SERVICE BULLETIN

00- T6. 09

MODELS CONCERNED: All C'series tractors

CONCERN: Bolt on 20" Rear Wheels

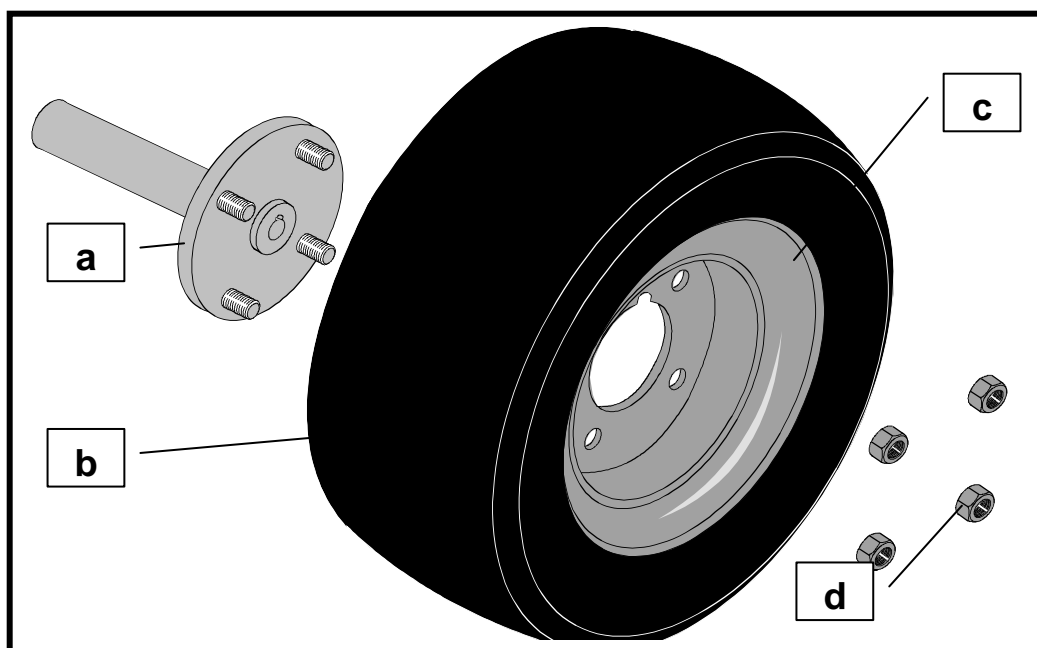
After serial number 000201..... all C'series tractors are now produced with 20" rear wheels & tyres. The wheels and tyres are now bolted to the transaxle using hubs.

Item	Description	Pt. No.
a	Transaxle Hub	198001300
b	20" Rear Tyre	198001200
c	20" Wheel Rim	198001100
d	Wheel Nut	048000800

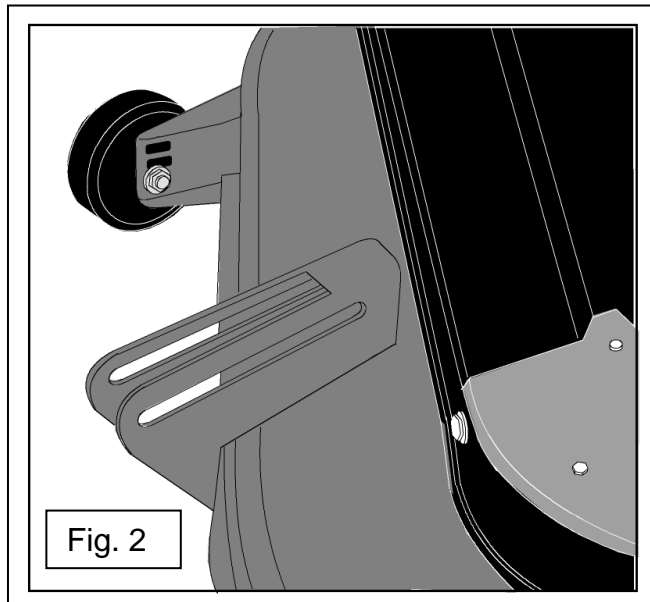
1. The front wheel stub axles are now standard number (L/H Pt. No. 327008900- R/H 327009000) these were originally used on the C800HE 1999 build tractors.
2. All decks now incorporate a new front deck mounting bracket raised 20mm.

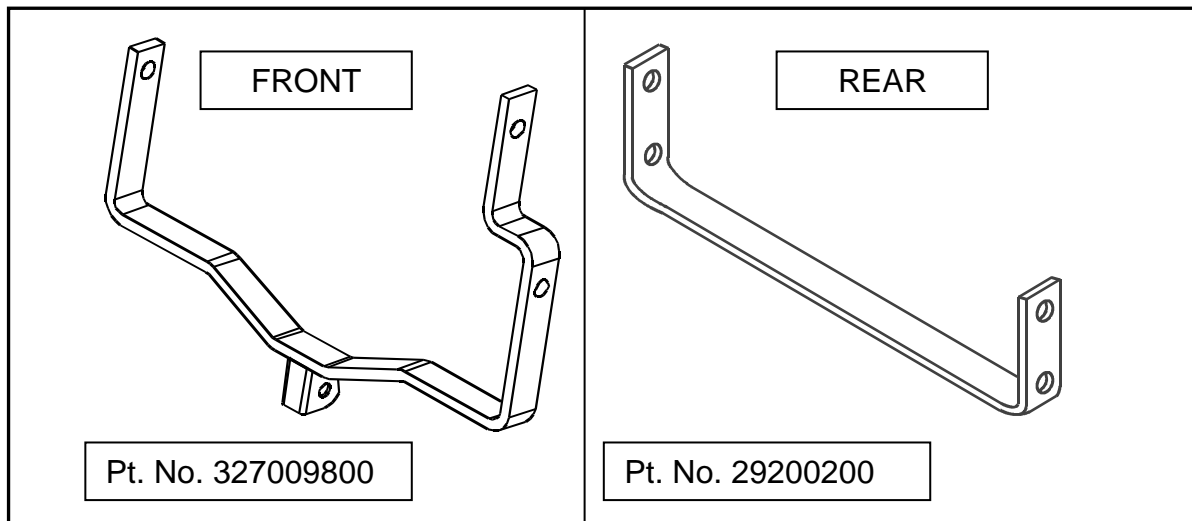
3. Both the front and rear deck-hanging brackets have been changed to accommodate the extra height.

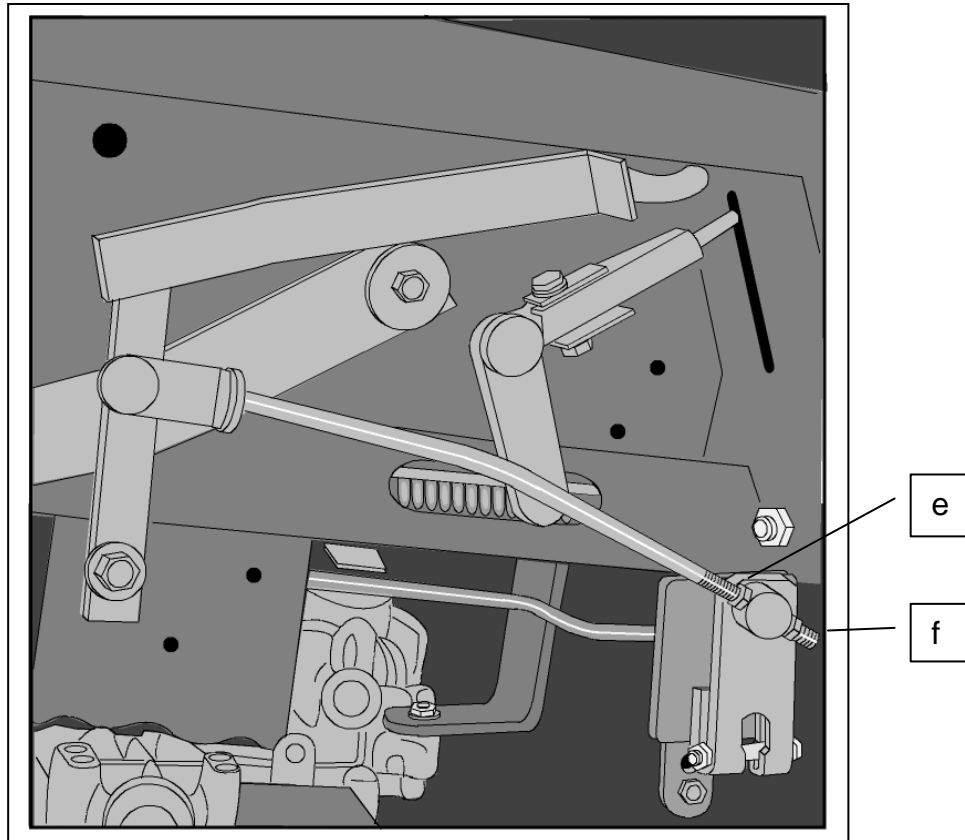
4. The deck height lever has been improved to make adjustments easier between deck changes. The maximum or minimum deck height can be set by simply adjusting the two lock nuts (e) and (f) to the appropriate height for Rear discharge, Mulching or Field mulching Decks.
